APPENDIX A TECHNICAL SPECIFICATION CHANGES

Sequoyah Nuclear Plant Unit 1 - Peaking Factor Limit Report

APPENDIX D REMOVAL OF ROD CONTROL RESTRICTIONS

FIGURE 3.2-3 RCS Total Flowrate Versus  $R_1$  and  $R_2$  - Four Loops in Operation

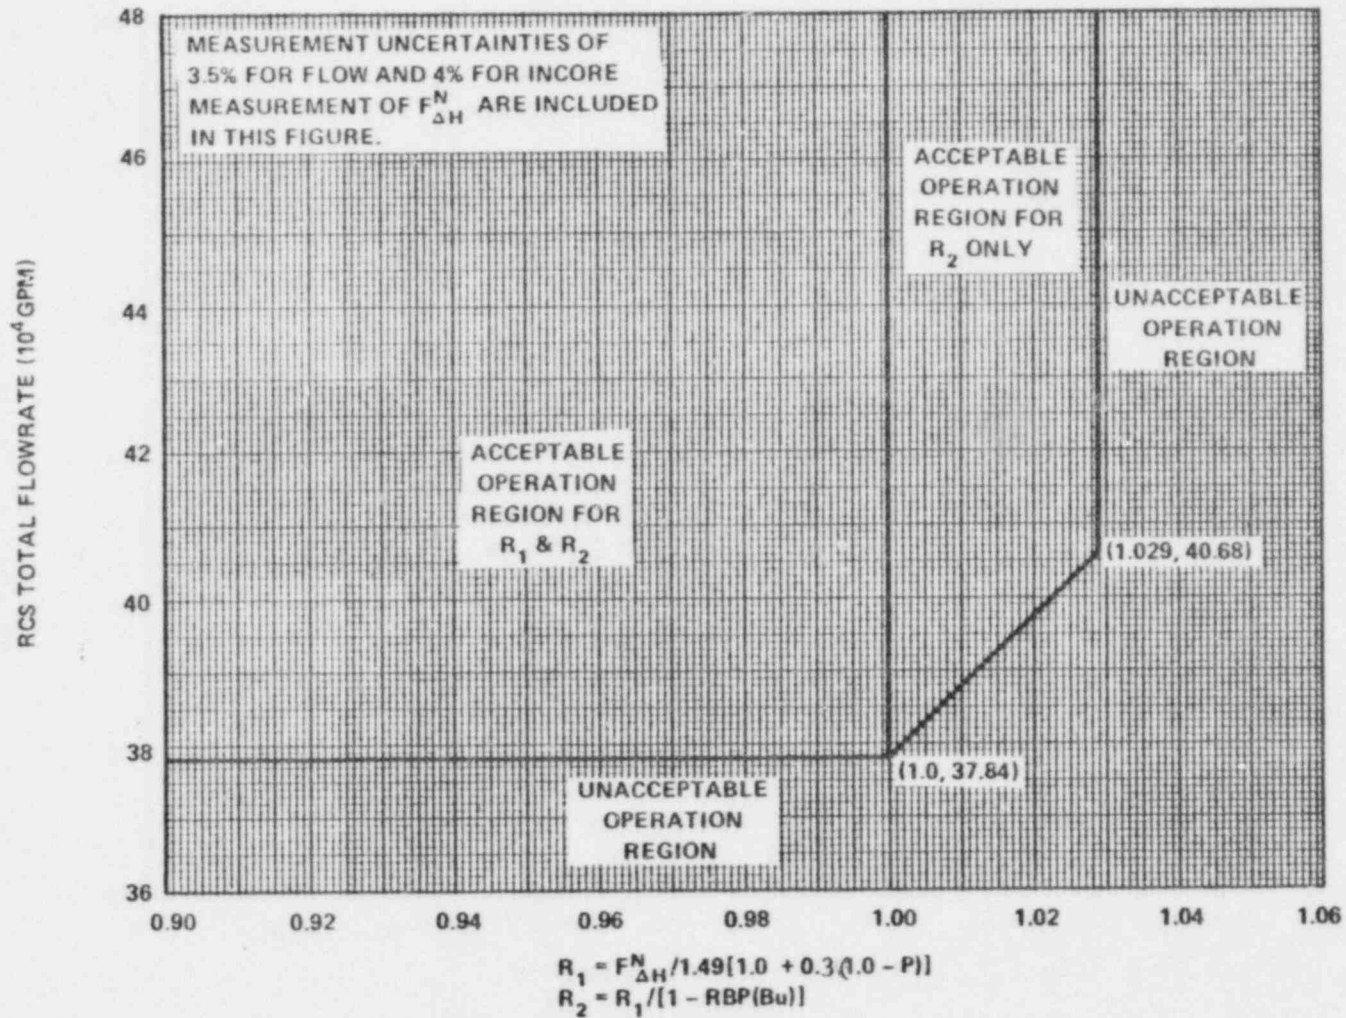
3.2.3 The combination of indicated Reactor Coolant System (RCS) total flow rate and  $R_1$ ,  $R_2$  shall be maintained within the regions of allowable operation shown on Figure 3.2-3 for 4 loop operation:

With the combination of RCS total flow rate and  $R_1$ ,  $R_2$  outside the regions of acceptable operation shown on Figure 3.2-3:

FIGURE 3.2-1

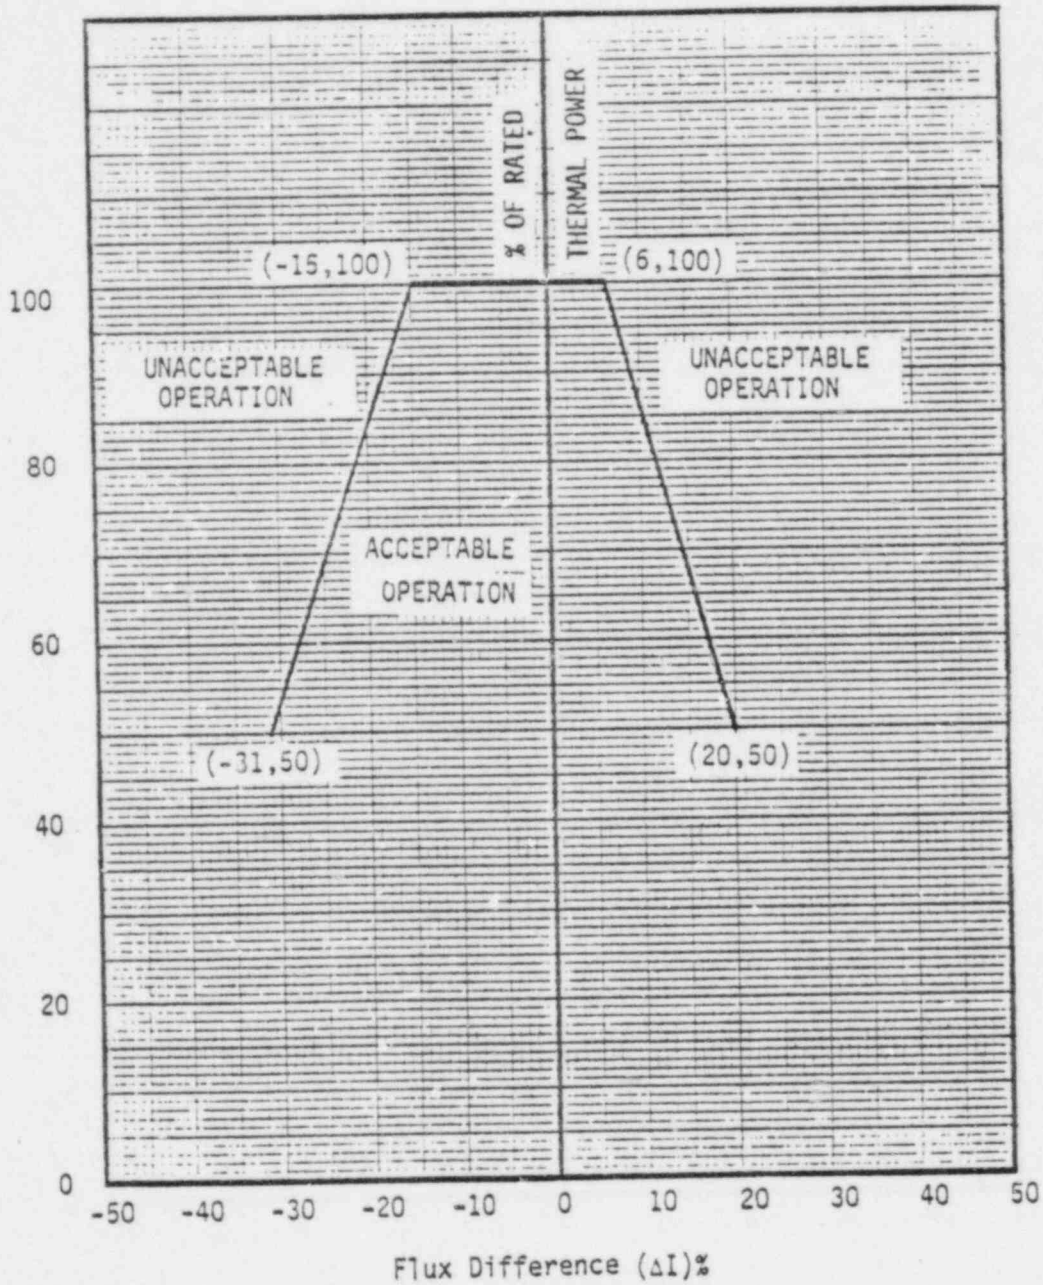
3.2.1 The indicated AXIAL FLUX DIFFERENCE (AFD) shall be maintained within the allowed operational space defined by Figure 3.2-1.

- a. With the indicated AXIAL FLUX DIFFERENCE outside of the Figure 3.2-1 limits,
  - 1.) Either restore the indicated AFD to within the Figure 3.2-1 limits within 15 minutes, or
  - 2.) Reduce THERMAL POWER to less than 50% of RATED THERMAL POWER within 30 minutes and reduce the Power Range Neutron Flux - High Trip setpoints to less than or equal to 55 percent of RATED THERMAL POWER within the next 4 hours.
- b. THERMAL POWER shall not be increased above 50% of RATED THERMAL POWER unless the indicated AFD is within the Figure 3.2-1 limits.

FIGURE 1  
 TYPICAL WESTINGHOUSE RELOAD CORE  
 RAOC W(Z)

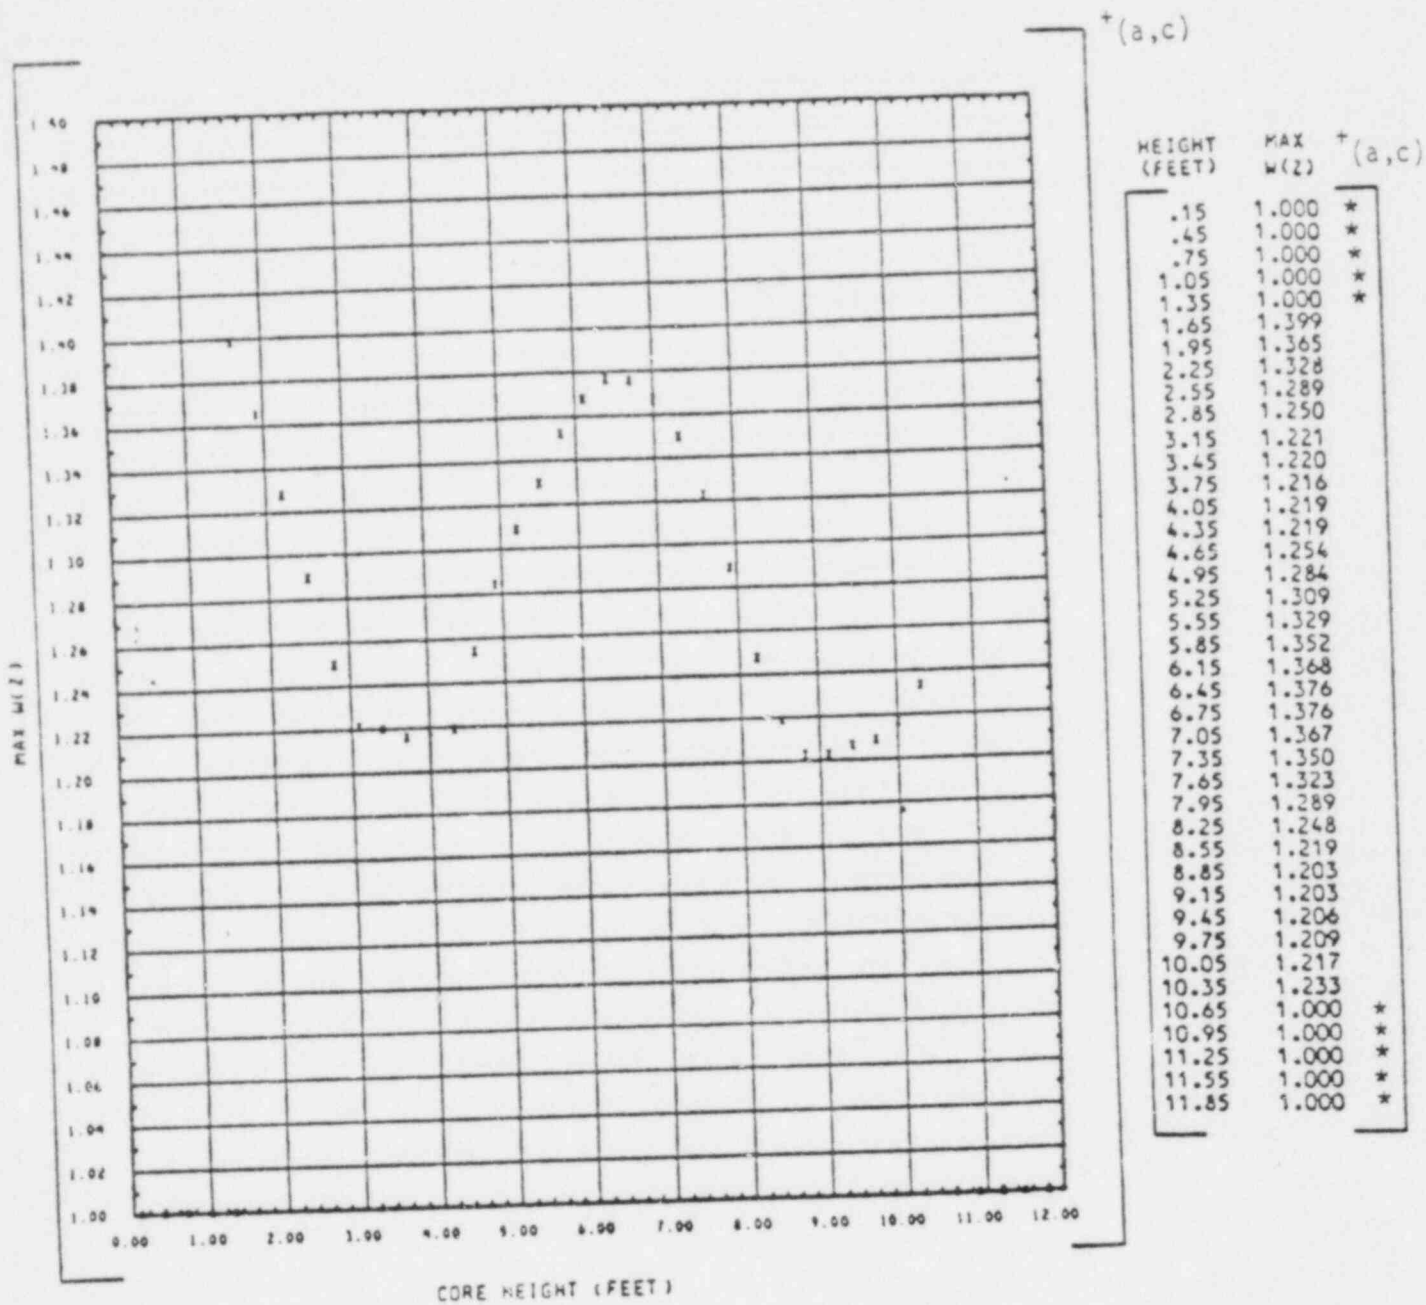
The cycle 2 W(z) function for RAOC operation is shown in figure 1. W(z) was calculated using the method described in NS-EPR-269, letter from E. P. Rahe (Westinghouse) to C. H. Burlinger (NRC) August 31, 1982.

This W(z) function is used to confirm that the heat flux hot channel factor,  $F_Q(z)$ , will be limited to the technical specification values of:
